Access Compliance Report

Public Rights-of-Way (Curb Ramps)

Intersection ID: 18350	Main Street: PROVIDENCE_RD	Cross Street: SHARON_LN	Location:	N
ADA ID: 6F64F8FA47DA	Ramp Type: Perp	Initial Pass/Fail: Fail	Overall Compliance: No	Severity Score: 8.75
Codes/Mitigation Info/Possible Solution		Field Measurements/Component Compliance

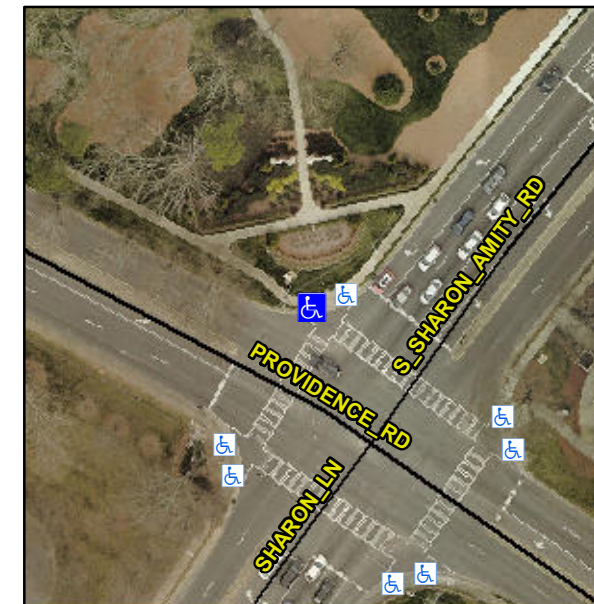
Not Found, R304.5.1

Compliance	Description	Data	Compliance	Description	Data
N/A	Ramp Length (in)	84.0	Yes	Ramp Slope (%)	7.0
No	Ramp Width (in)	46.0	Yes	Ramp XSlope (%)	1.7
N/A	Flare Type LT	N/A	N/A	Flare Type RT	N/A
N/A	Flare Slope LT (%)	N/A	N/A	Flare Slope RT (%)	N/A
N/A	Flare Traversable LT?	N/A	N/A	Flare Traversable RT?	N/A
N/A	Landing Length (in)	N/A	N/A	DWS Provided?	N/A
N/A	Landing Width (in)	N/A	N/A	DWS Contrast?	N/A
N/A	Landing Slope (%)	N/A	N/A	DWS Length (in)	N/A
N/A	Landing X Slope (%)	N/A	N/A	DWS Full Width?	N/A
N/A	Landing Curb? (Y/N)	N/A	N/A	DWS Offset (in)	N/A
N/A	Shared Landing?	N/A			
N/A	Gutter Ponding?	N/A	N/A	Gutter Slope (%)	N/A
N/A	Gutter Lip Ht (in)	N/A	N/A	Gutter X Slope (%)	N/A
N/A	Painted X Walk1?	Yes	N/A	Painted X Walk2?	N/A
	X Walk 1 Direction	To SW		X Walk 2 Direction	N/A
N/A	X Walk 1 Width (in)	110.0	N/A	X Walk 2 Width (in)	N/A
	X Walk 1 Slope (%)	1.0		X Walk 2 Slope (%)	N/A
	X Walk 1 X Slope (%)	0.7		X Walk 2 X Slope (%)	N/A

Remove & Replace Entire Ramp.
